RAPID UPDATE 555

Rapid Update 555 Grecale - BSM Software Update

DATE: DECEMBER 13 2022

The Sw below (or newer one) must be installed

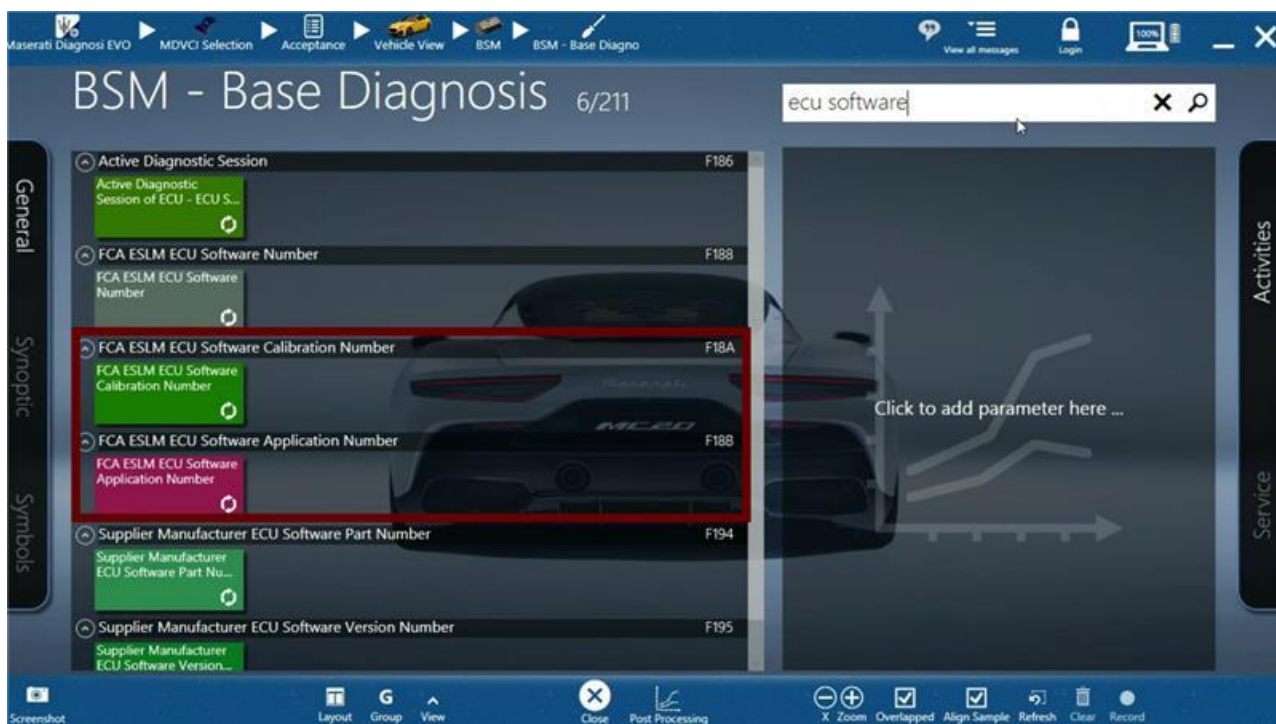
Market	Engine	F187	F18B	F18A
NAFTA	MHEV	670219050	670297607	670298527
	V6 TROFEO	670219051	670297607	670298527

Note: after the BSM - ECU Programming, please make sure in the BSM - Base Diagnosis - F18A - FCA ESLM ECU Software Calibration Number and in the BSM - Base Diagnosis - F18B - FCA ESLM ECU Software Application Number that the new software has been installed correctly.
